UNITED STATES PATENT AND TRADEMARK OFFICE

APPLICATION NO.	FILING DATE	FIRST NAMED INVENTOR	ATTORNEY DOCKET NO.	CONFIRMATION NO.
10/730,440	12/08/2003	Chandra Sekhar Namuduri	GP-303152	2250

Office Action Summary	Application No. 10/730,440	Applicant(s) NAMUDURI, CHANDRA SEKHAR	
	Examiner Melody M. Burch	Art Unit 3683

DETAILED ACTION

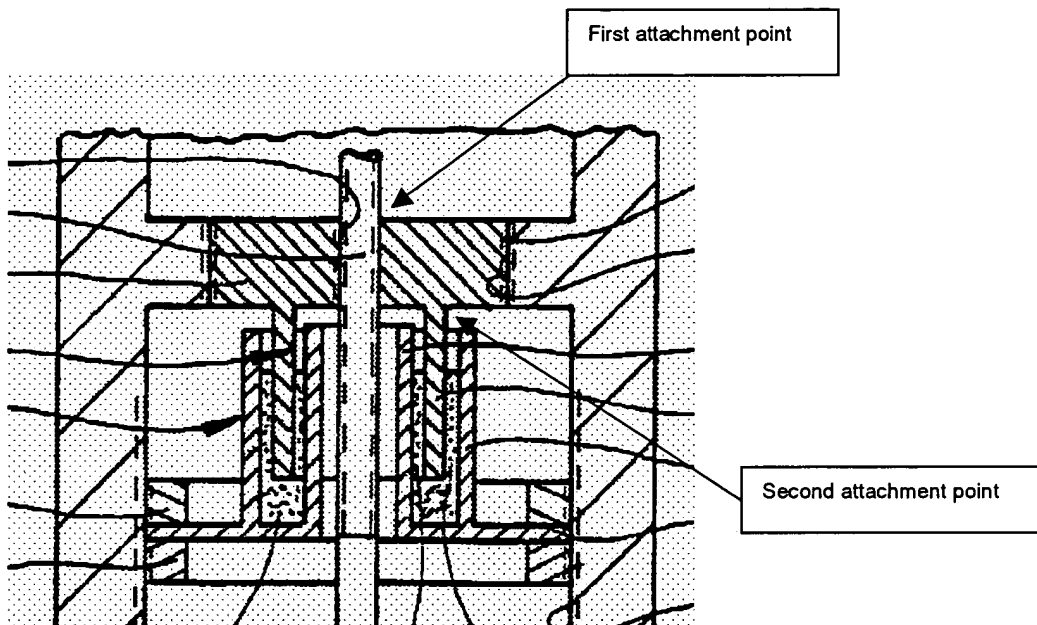
Re: claims 1, 2, 7, and 12. Weyand shows in figure 2 a damping apparatus comprising: a linear to rotary conversion mechanism comprising a translatable member 34 having a first attachment point as shown in the labeled version of figure 2 of Weyand shown on the following page that is adapted for generally linear translation in a forward and a reverse direction and a rotatable member 34 comprising a rotatable shaft that is

rotatably coupled to the translatable member; wherein translation of the translatable member in one of the forward or the reverse directions produces a forward or a reverse rotation of the rotatable member and shaft, respectively, and a damping mechanism comprising a second attachment point as shown in the labeled version of figure 2 of Weyand, a hub 32 that is fixed to the shaft.

Re: claims 4, 9, and 14. Weyand, as modified, teaches in figure 2 of Weyand a translatable member 34 (34 undergoes a slight axial movement as disclosed in col. 2 lines 61-62 and a rotatable member 10 (member capable of being rotated along the threads) comprises a ball screw.

Re: claims 6 and 11. Weyand, as modified, describe the invention as set forth above in the rejection of claim 1 and also includes (as shown in figure 2 of Weyand) a housing 14 having a first end shown in the area of the lead line of number 48 with a bore that is adapted to rotatably receive the shaft therethrough, a sidewall 30 having an inner surface and a second end opposite the first end, the hub 32 having an outer surface proximate a portion of the inner surface of the sidewall such that the outer surface of the hub and sidewall of the housing define a channel therebetween as shown in figure 2 of Weyand.

Re: claim 16. Weyand, as modified, teach in figure 2 of Weyand the limitation wherein the hub comprises a cylindrical base (the upper part of the hub) having an outer rim and that is fixed to the shaft (integrally fixed) and a cylindrical wall (the lower part of the hub) extending from the outer rim and located adjacent to the inner surface of the sidewall of the housing, wherein a first portion between the sidewall of the housing and the cylindrical wall of the hub comprises the channel.

Re: claim 20. Weyand, as modified, teaches in Weyand the damper further comprising a cylindrical core 20 attached to the second end of the housing and extending along and adjacent to the cylindrical wall of the hub wherein a second portion between the cylindrical wall of the hub and the cylindrical core further comprises the channel as shown in figure 2.
